APPLICATION NO.	FILING DATE	FIRST NAMED INVENTOR	ATTORNEY DOCKET NO.	CONFIRMATION NO.
10/601,789	06/24/2003	Norio Kimura	2003-0865	9516

Office Action Summary	Application No.	Applicant(s)	
	10/601,789	KIMURA ET AL.	
	Examiner	Art Unit	
	Hadi Shakeri	3723

DETAILED ACTION

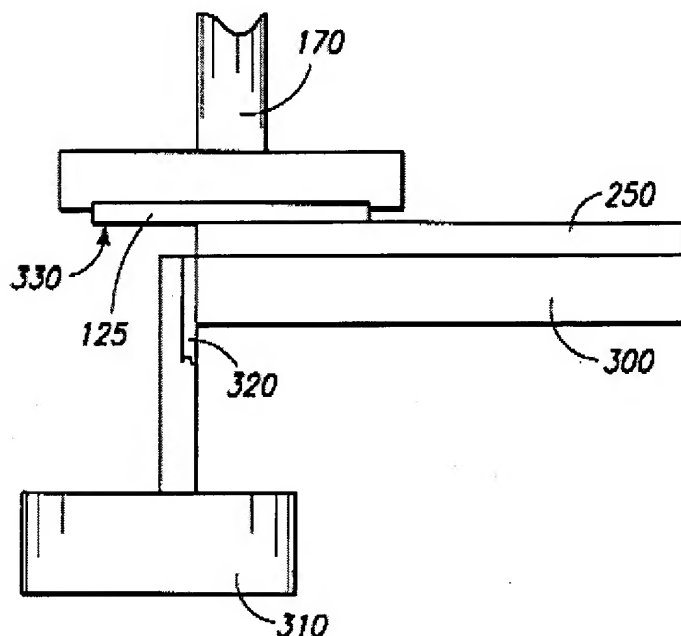
4. Claim 3 is rejected under 35 U.S.C. 102(b) as being anticipated by either Takahashi et al. or Schultz (US 5,672,091 or 5,081,796).

Both Takahashi et al. and Shultz disclose all the limitations of claim 3, i.e., a polishing apparatus comprising a polishing table having a polishing surface; a substrate carrier; and an actuator for altering a force acting on the substrate and the polishing surface. It is noted that in an apparatus claim, the functional, narrative or intended use language not resulting in a structural difference to read over prior art is considered met, i.e., the apparatus is capable of performing the functions.

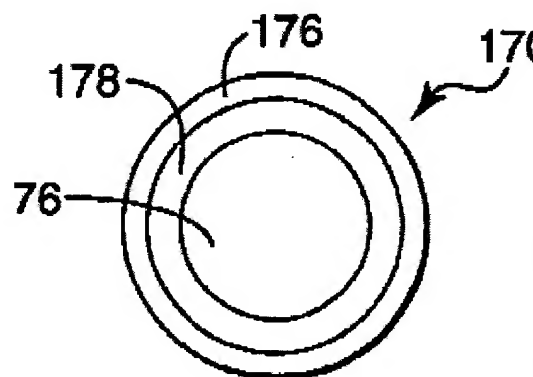
6. Claims 11-13 are rejected under 35 U.S.C. 102(e) as being anticipated by Muilenburg et al. (US 6,604,985).

Muilenburg et al. discloses all the limitations of claim 11, i.e., a polishing table having a polishing surface (shown here as 76) and a transparent ring (178) positioned outside and fixedly connected to an outer peripheral edge of the polishing surface, the transparent ring having a flat surface which is flush with the

polishing surface of the polishing table.

Regarding claims 12 and 13, Muilenburg et al. meets the limitations, i.e., sensor (50) monitoring the degree of planarization, and wherein the carrier head is capable to move the wafer between the polishing surface (76) and extending partly outwardly from the outer periphery of the surface, e.g., partially over (178).

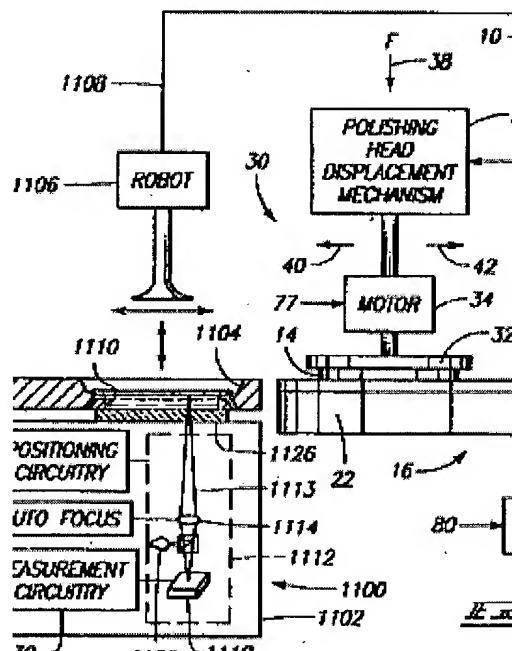
7. Claims 14-16 are rejected under 35 U.S.C. 102(b) as being anticipated by Sandhu et al. (US 5,730,642).

Sandhu et al. discloses all the limitations of claim 14, i.e., a polishing table having a polishing surface; and a stationary transparent member positioned outside, spaced away from and adjacent to an outer peripheral edge of the polishing surface, the stationary transparent member (1126) having a flat surface (the upper surface as shown) which is flush with the polishing surface of the polishing table.

Regarding claims 15 and 16, Sandhu et al. meets the limitations, i.e., (1100) and wherein the wafer carrier (1106) is capable to move the wafer between the polishing surface and the transparent member, whether partially or fully.
